**THE PORT AUTHORITY OF NEW YORK AND NEW JERSEY
TWO MONTGOMERY STREET - 1st FLOOR
JERSEY CITY, NJ 07302**

ADDENDUM NO. 9

**TO PROSPECTIVE BIDDERS ON CONTRACT AKO-284.051 - OUTERBRIDGE
CROSSING - MAIN SPAN PIER AND FENDER UPGRADES**

WALKWAY TO FALCON NEST ELEVATION

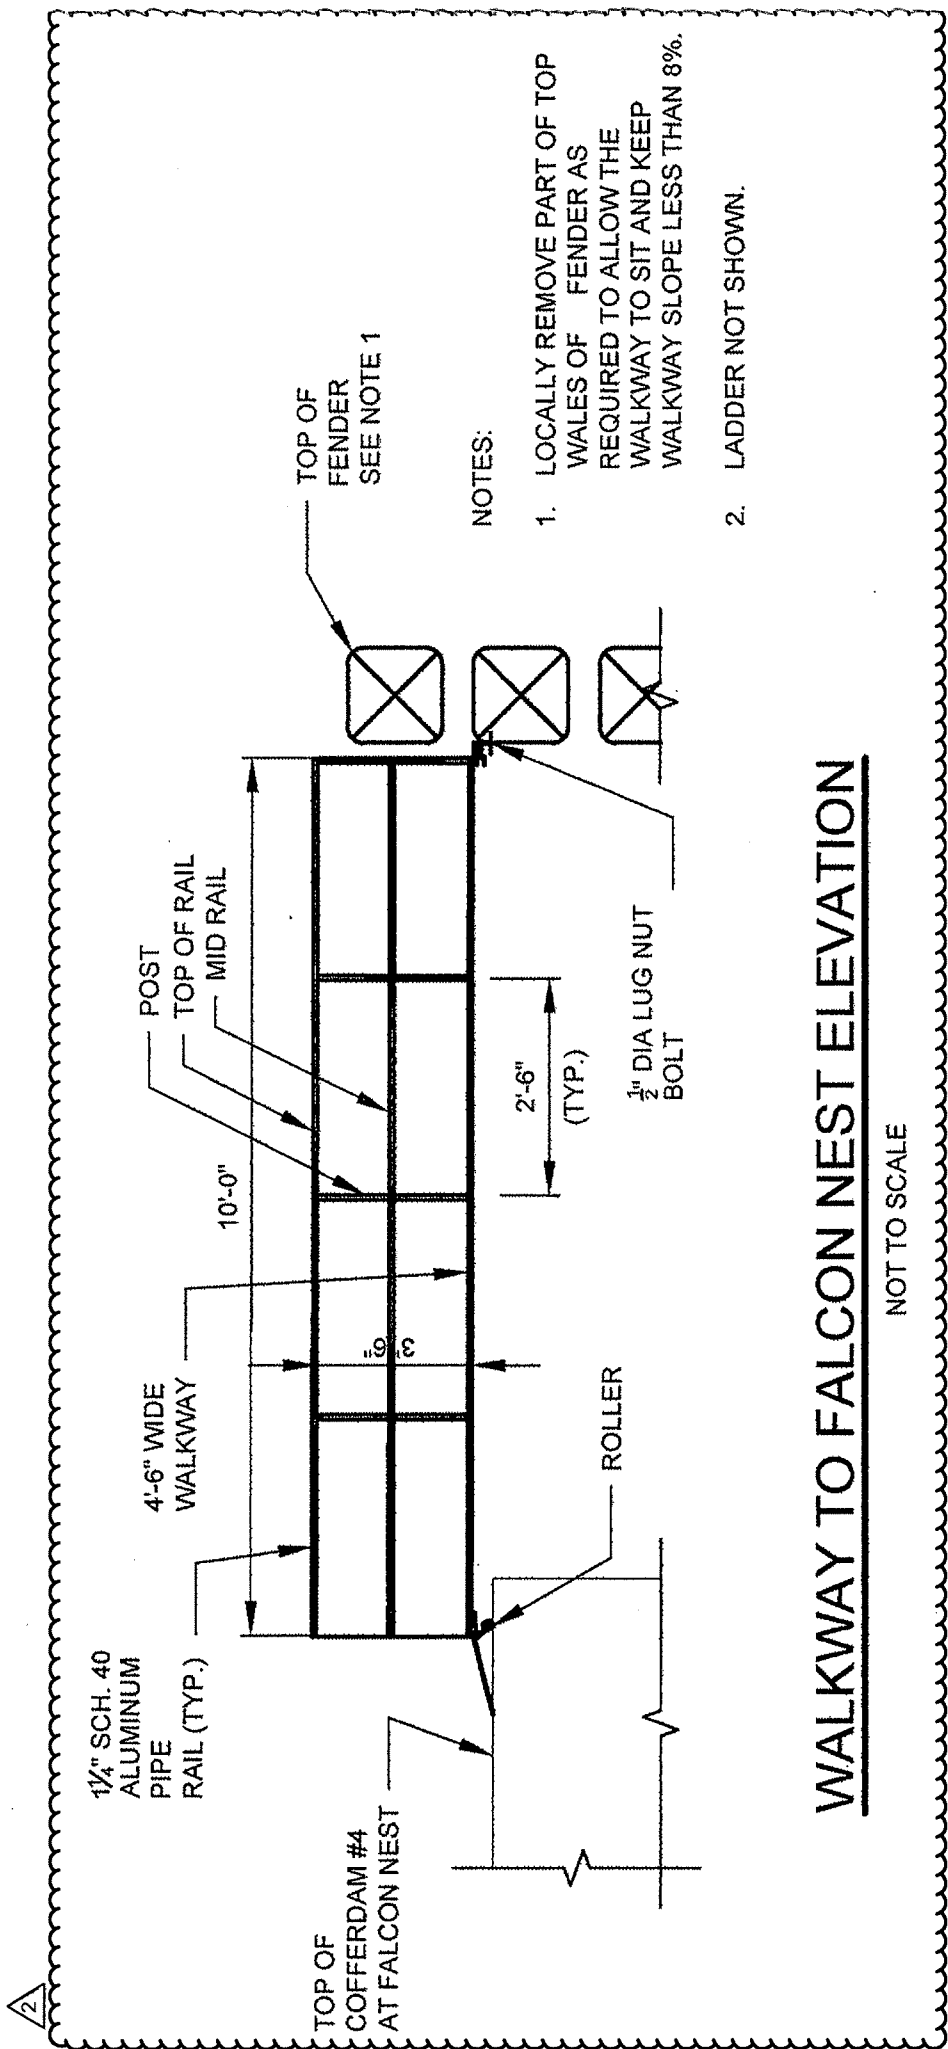
- Dwg S001- Immediately after the end of Note 3.12, insert the following new note:
"3.13 THE 36" AND 12" DIAMETER STEEL PILE DIMENSIONS REFER TO THE OUTSIDE DIAMETER OF THE PILES."
- Dwg S107- Make the following changes:
A. Under SECTION S-3, delete "THREADED BARS" and substitute therefor "BOLTS".
B. Under SECTION S-3, add "FIBERGLASS" before "SPlice CHANNEL".
C. In the title of detail "WALE SPLICE DETAIL" add "FIBERGLASS" before "WALE".
- Dwg S110- Revise the drawing as shown on Sketch SK-A2 which is attached hereto and made a part hereof.

1. LOCALLY REMOVE PART OF TOP WALES OF FENDER AS REQUIRED TO ALLOW THE WALKWAY TO SIT AND KEEP WALKWAY SLOPE LESS THAN 8%.
2. LADDER NOT SHOWN.
